2011 Change Proposals - New Allowances (4 Items)

These are **PROPOSED** Changes only based on driver and director suggestions. Please comment below. These are prposed NEW allowances to the 944 spec rule set.

2011-3) Allow 924S models to use 924 Carrera GT type flares on the rear.

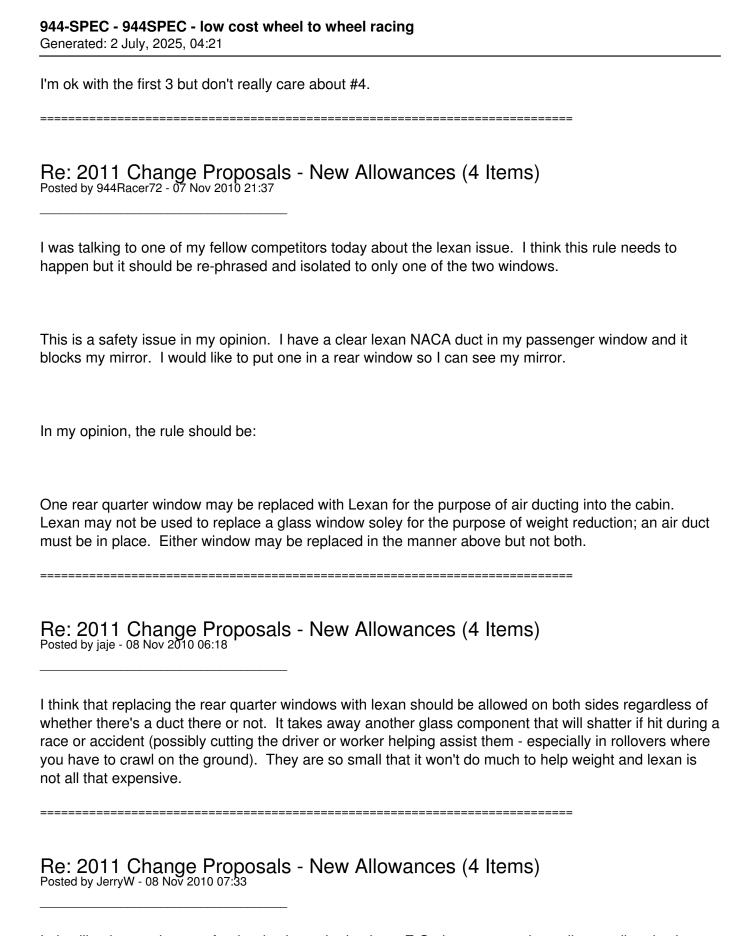
Proposal: All 87 and 924S chassis to install fiberglass 924 Carrera GT/ GTS type rear flares. Flares limited to units produce by GT racing part number xxxx (TBD). Track with may be increased the limit of the 944. If rear flares are installed the front must also convert to 944 steel fenders.

Justification: This allows a simple easy way for a narrow 924S to achieve the same track width as allowed by the 944. Front bodywork will be identical to the 944 and the rear flares are a cheaper solution than using 944 rear qtr panels.
